# **ADDENDUM NO. 1**

**August 21, 2020**

**BOURNS FACP REPLACEMENT  
PROJECT NO. 950567  
CONTRACT NO. 112003-LF-2020-110**

SHEET TITLE  
**1ST. FLOOR REMODEL FIRE ALARM PLAN - OFFICE BLDG. A WEST**

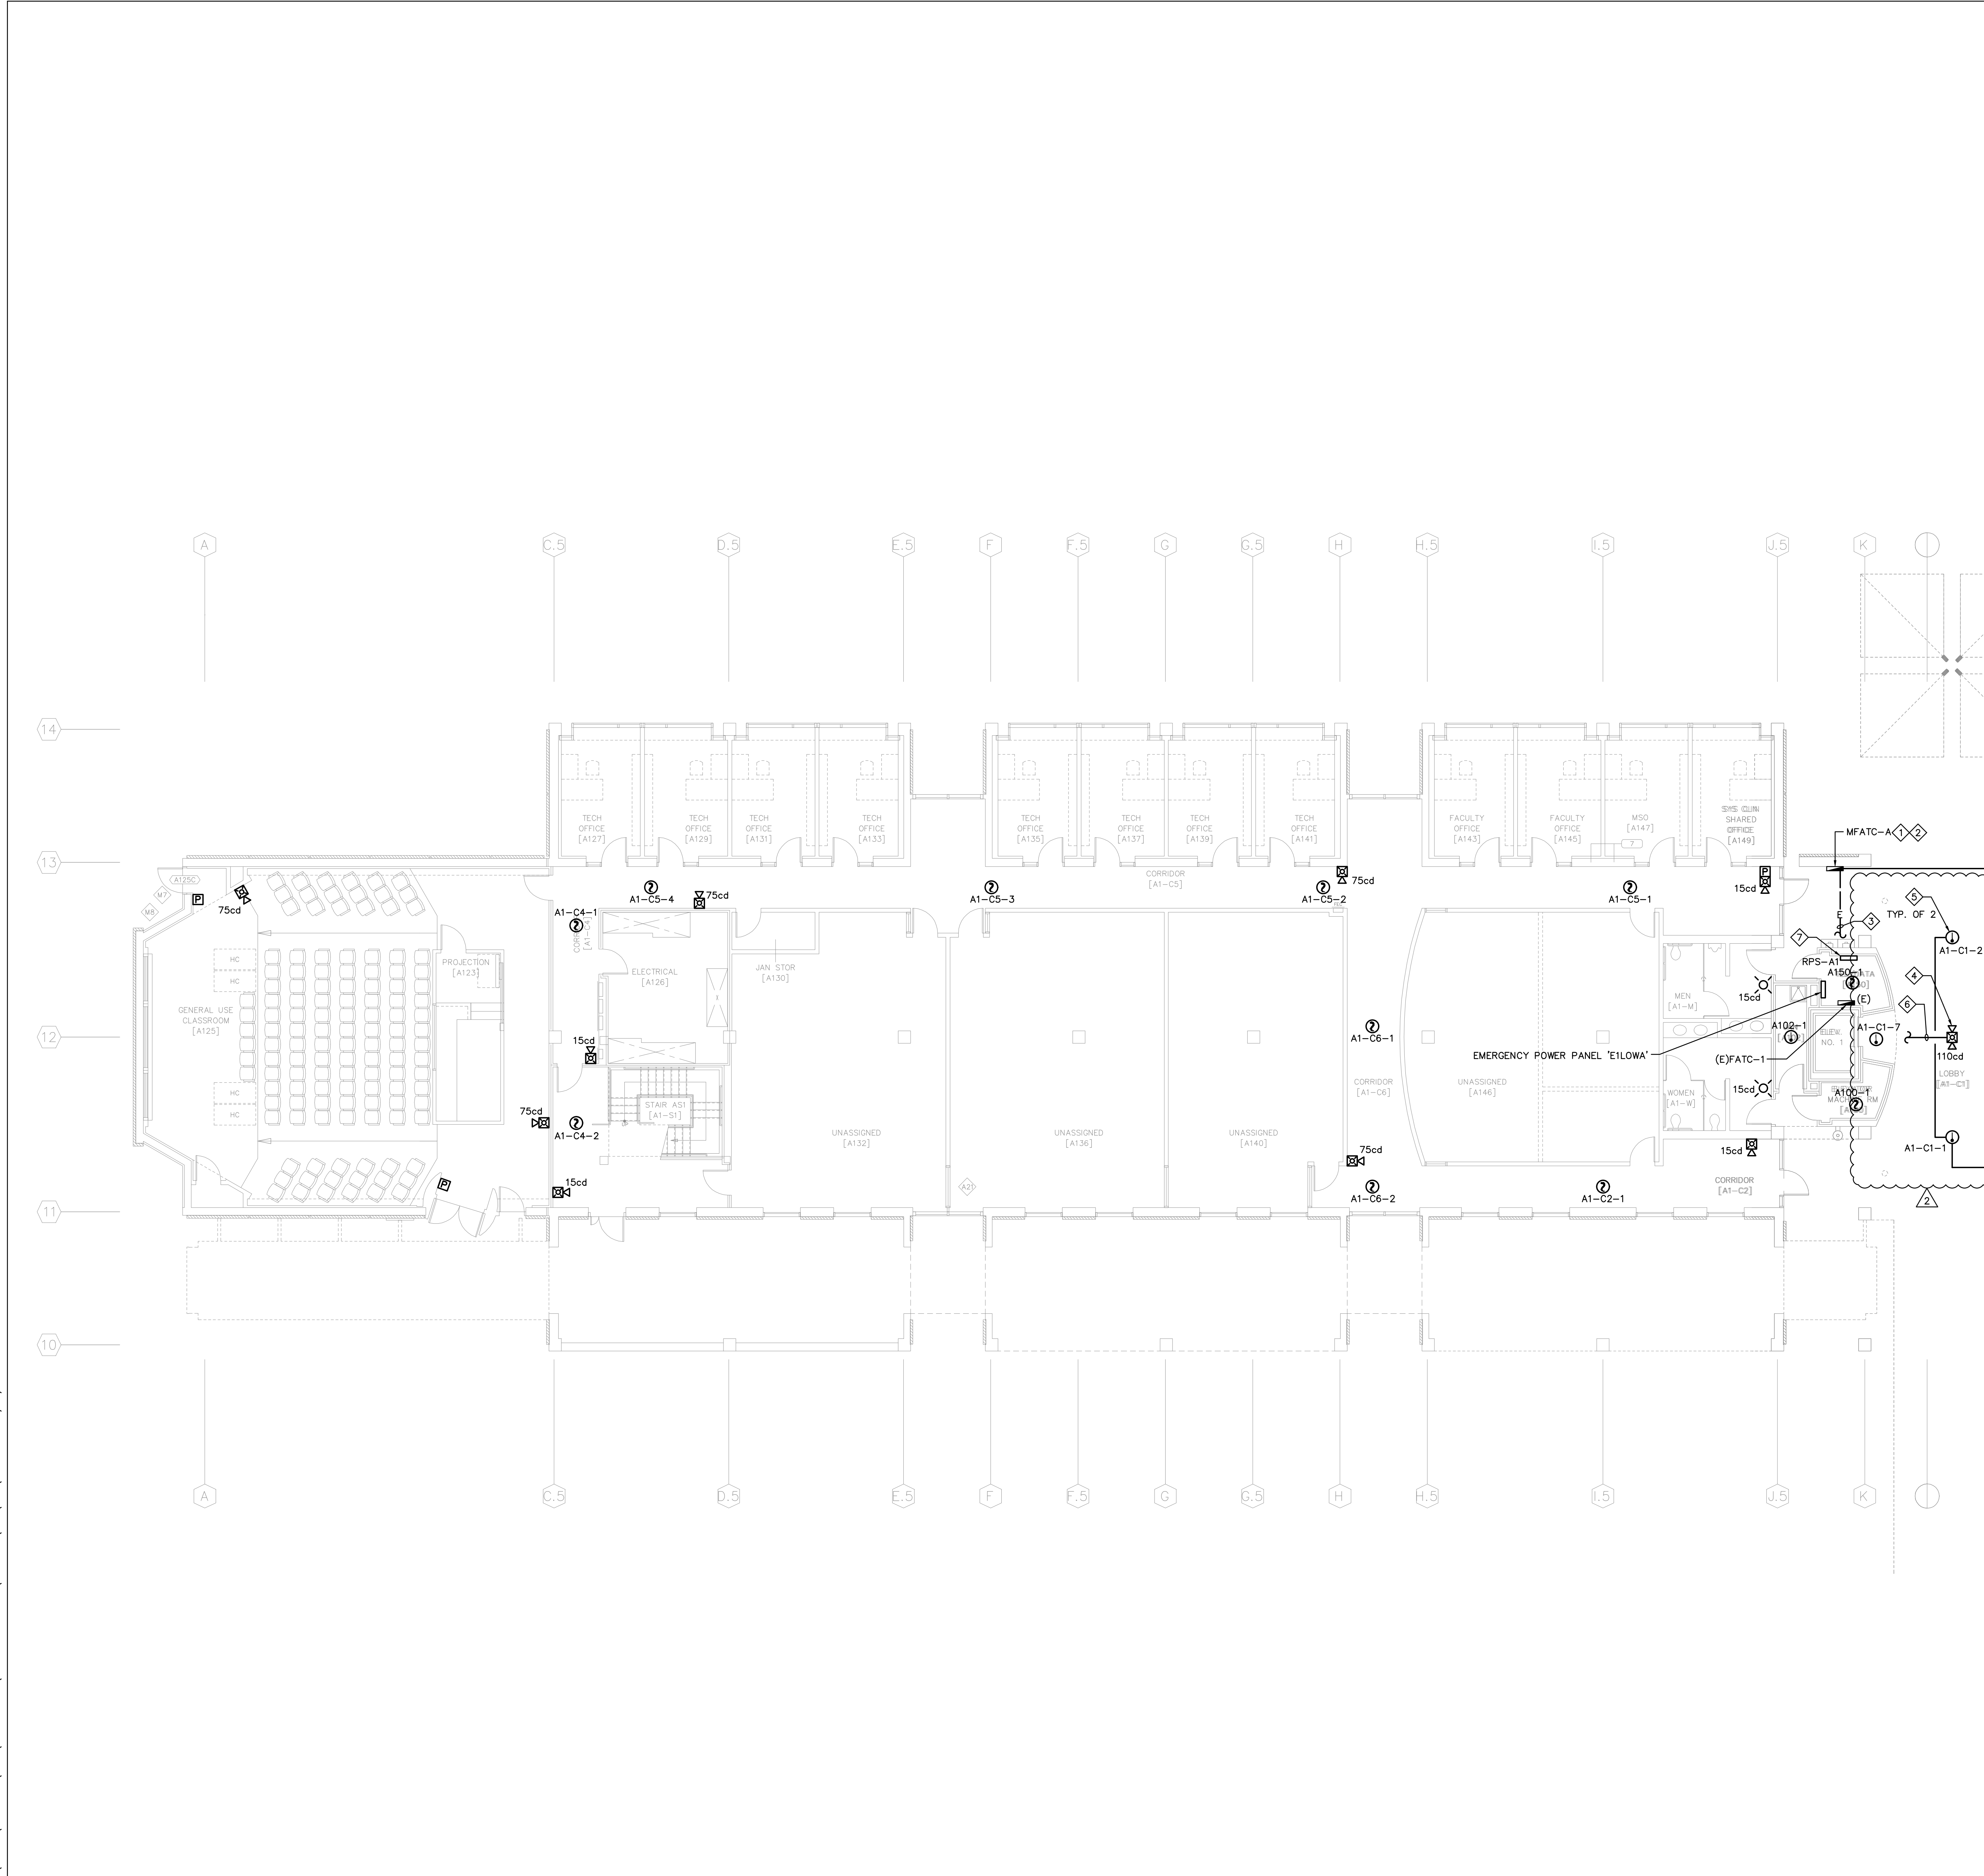
Remove sheets E2.1, E2.2, E2.3, E2.5, E2.6, E2.9 and E2.10 and replace them with the sheets issued in the Addendum.

SHEET TITLE  
**2ND. FLOOR REMODEL FIRE ALARM PLAN - OFFICE BLDG. A WEST**

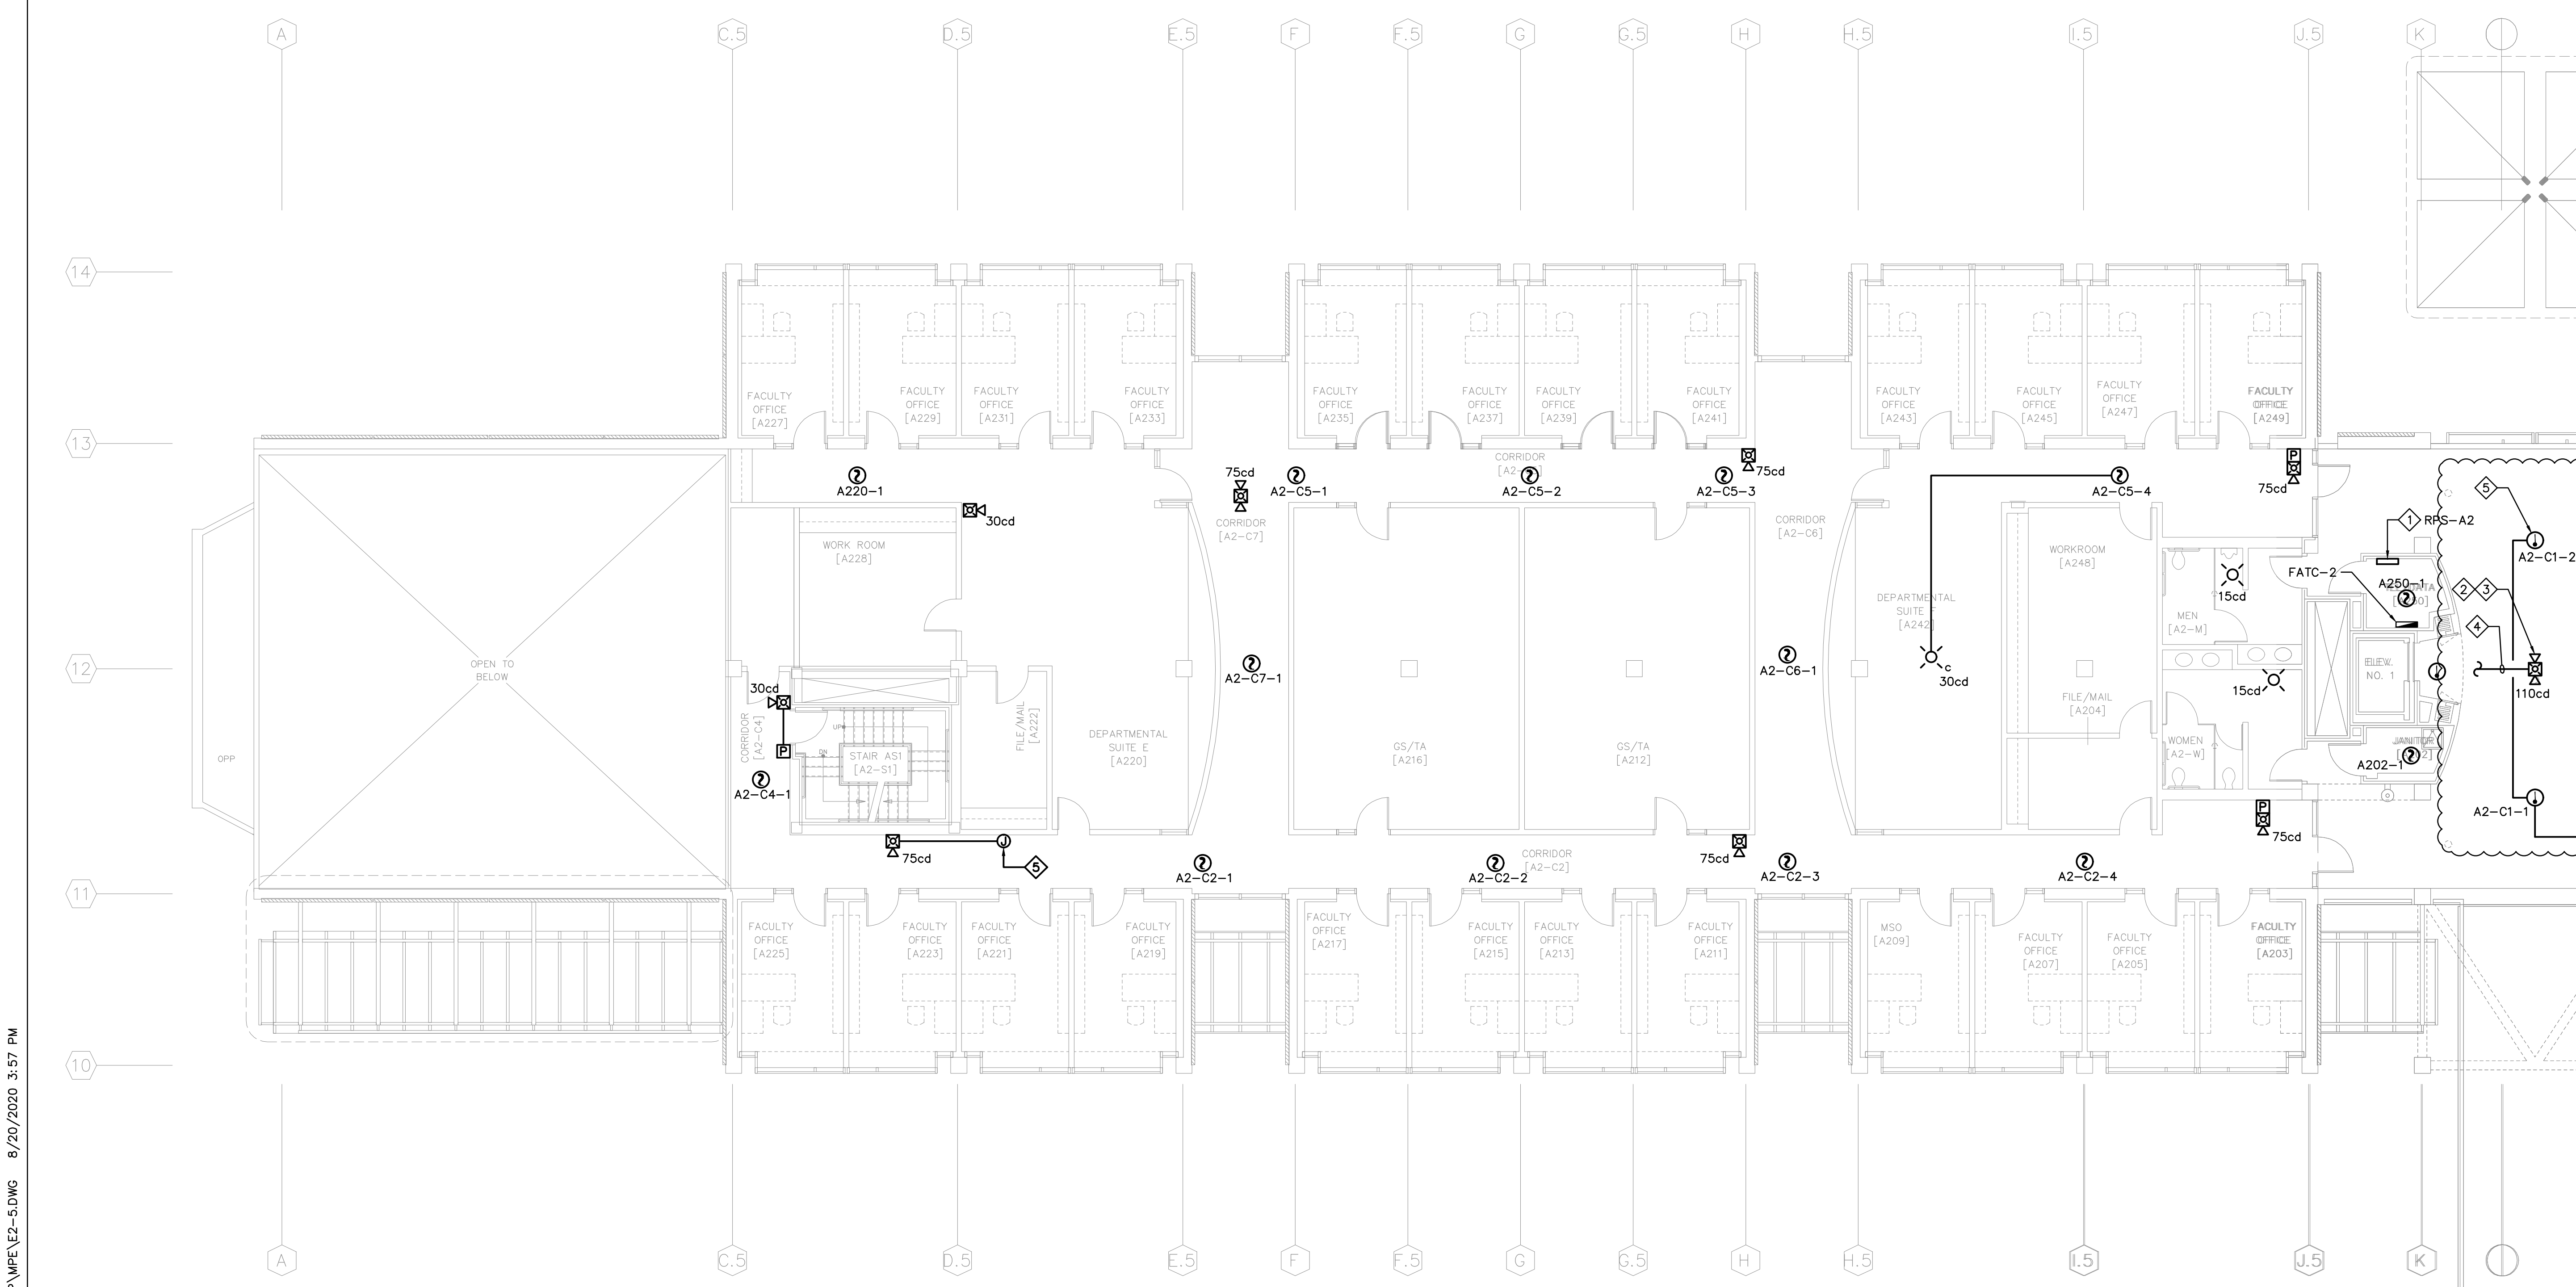
<p><b>Answer:</b> With “WP” indication only.</p>
1-11	<p><b>Question:</b> Building “A” first, second and third floor lobbies are completely open to the north and south to the exterior. The Elevators have existing heat detectors for capture recall and to close the fire rated retractable door assemblies on the Second and Third Floors. There are 18 total new smoke detectors indicated to be installed on an exterior open foyer which is wide open to weather conditions from the north and south. (6 new detectors per floor). Six new smoke detectors are indicated on the first, second and third floor in this foyer which is open to weather conditions. Should the six smoke detectors located in lobbies A1-C1, A2-C1 and A3-C1 have their scope of installation omitted from the project due to the area being outdoor and being currently protected by automatic fire sprinklers and the elevator capture / recall detector on each outdoor landing?</p> <p><b>Answer:</b> Provide (2) weatherproof heat detectors in each floor, total of 6. To be added in the addendum.</p>

1-12	<p><b>Question:</b> Building “A” first, second and third floor lobbies direct the installation of a new wall mounted horn / strobe south of the elevator door. The extension of conduit to serve these three new notification appliances is from an existing notification appliance north of each of the elevator doors. This area is outdoor, the surface selected for the new notification appliances is on a polished Granite slab. Should there be a need for a new 75cd horn strobe in the new locations south of the elevator door considering this is outdoors? If so, a single ceiling horn / strobe placed in the center of lobbies A1-C1, A2-C1 and A3-C1 would be most ideal, reduce installation cost, prevent contractors from potential damage to the polished Granite slab and provide uniform coverage with greater area of coverage than two in the selected locations. May the contractors omit wall mounted horn strobes on the Elevator granite slab wall north and south of the elevator doors and install a single ceiling horn strobe in the center of the soffit ceiling of lobbies A1-C1, A2-C1 and A3-C1 to reduce risk of granite damage and cost of installation to the owner?</p> <p><b>Answer:</b> Acceptable, provide (1) ceiling Horn/Strobe center of soffit with adequate coverage per floor.</p>
